FR Technical Regulations Bulletin

No: FR-TRB-2026-01
Date: June 8, 2026
Subject: Technical Regulation Updates, Clarifications & Corrections

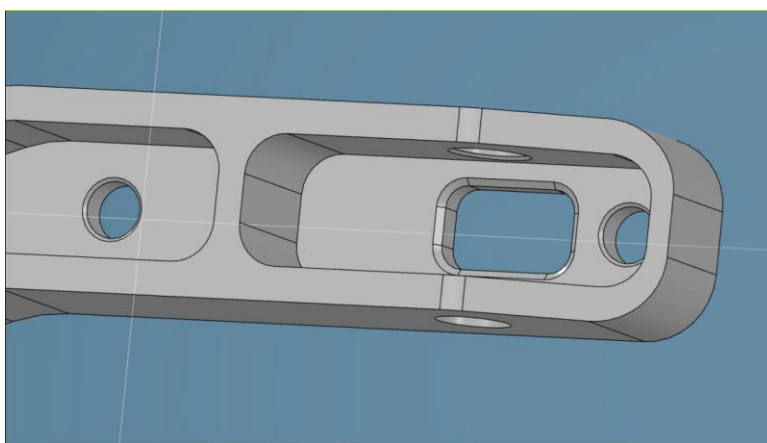
7. **Article 26.3.2 Chassis & Bodywork:** Update & clarify this section by adding the text and diagram from Ligier JS F3 Tech Bulletin #10-2.4.2021 to the end of the section.

Per Ligier JS F3 Tech Bulletin #10-2.4.2021 - FRONT WING SPACER 08-13-2013 - The front wing spacer 08-13-2013 (#8 Shown Below) may be removed. The acceptable inspection height of the stack of wing spacers is a total of either 35mm or 40mm.

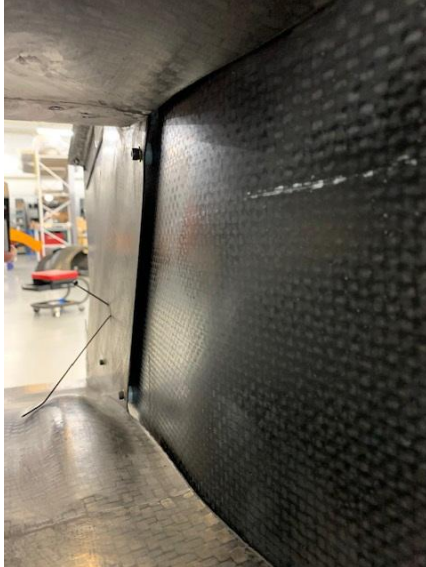
28.9 Per Ligier JS F3 Tech Bulletin #3-8.15.2019 - ECU COOLING DUCT 08-14-059 A – Mandatory Update - Ligier Automotive North America together with HPD have completed a study to combat increased ECU area temperatures negatively effecting the ECU. The design office has created a NACA-style duct to best compromise between aero performance and maximum ECU cooling.

Spacers in place in right side pod.

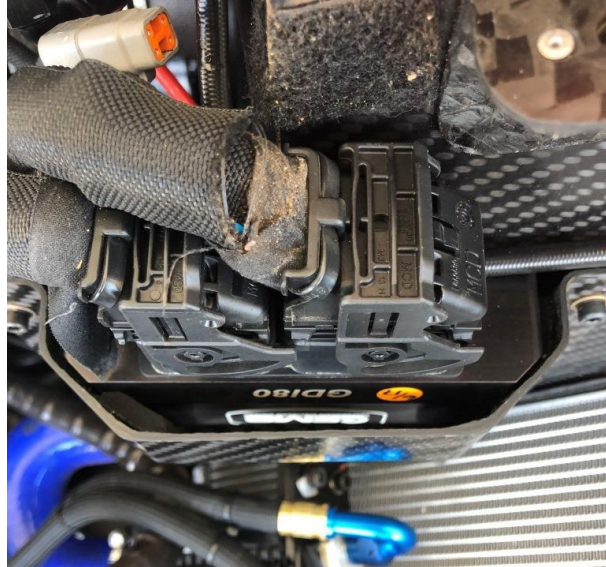
28.11 Per Ligier Tech Bulletin #11-3.8.2021 – This is a mandatory modification – Rad Duct Spacer 08-14-061 – Ligier has provided spacers which, when installed between the tub and the inlet duct in the right sidepod, have been shown to decrease ECU temperatures and reduce the risk of the ECU shutting down the engine during pace laps or on pit lane. Spacers must be added in the below locations between the RH Radiator duct and the monocoque to promote airflow to the ECU. Removing the foam surrounding the ECU has also been shown to decrease ECU temperatures.

Foam around ECU removed.

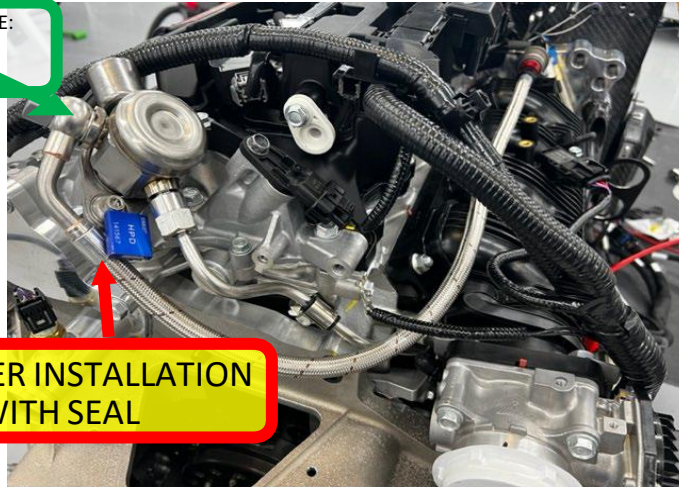
28.12 Per Ligier JS F3 Tech Bulletin #12-5.10.2022 - FUEL LINE UPDATE SP4208-010, HOSE CLAMP 3225T5 – The low pressure side fuel line has been updated to increase longevity and combat any clearance issues with the airbox. Additionally, a hose clamp is added to guide the hose. This is a mandatory update, Type 1 part.

Each line comes with 2 new OE sealing washers (PN 90428-RPY-G01) to be replaced at the time of installation. It is required to use the Honda banjo “nut” that is on the High-Pressure Pump. Banjo Nut Torque: 24 lb-ft.

The angle of the line should be such that it does not rub against another component, pay special attention to ensure the engine seal is not in contact with the line. (see picture below)

!!CAUTION! - ONLY THE HOSE CLAMP SPECIFIED MAY BE USED. THE HOSE CLAMP IS USED AS A GUIDE SO IT MUST BE A 'LOOSE' FIT ON THE FUEL LINE, NOT CLAMPED TO THE LINE. (see picture below)
